Brightline West Cajon Pass High Speed Rail Project Environmental Assessment

Errata Memorandum

DEPARTMENT OF TRANSPORTATION
Federal Railroad Administration (FRA), December 2022

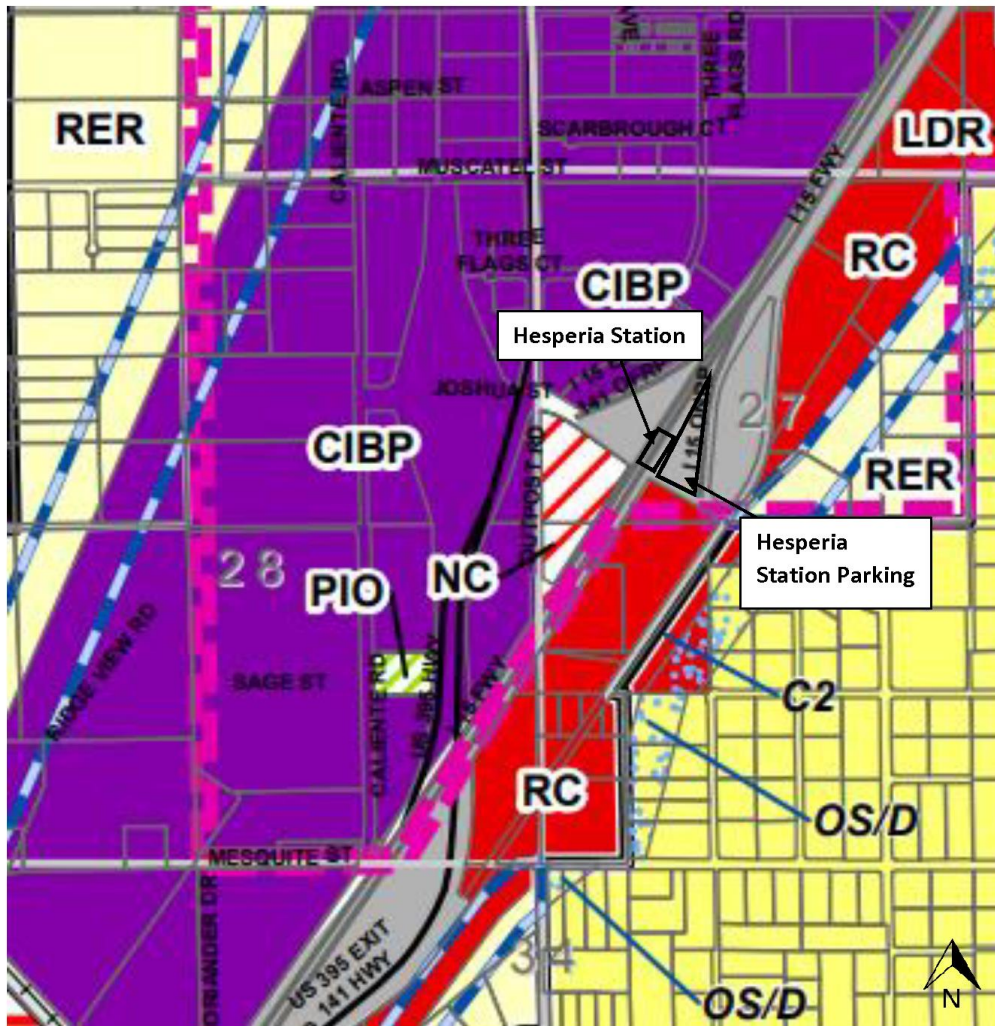
In Section 4.8.4, Affected Environment, the following revisions are made to Figure 12:
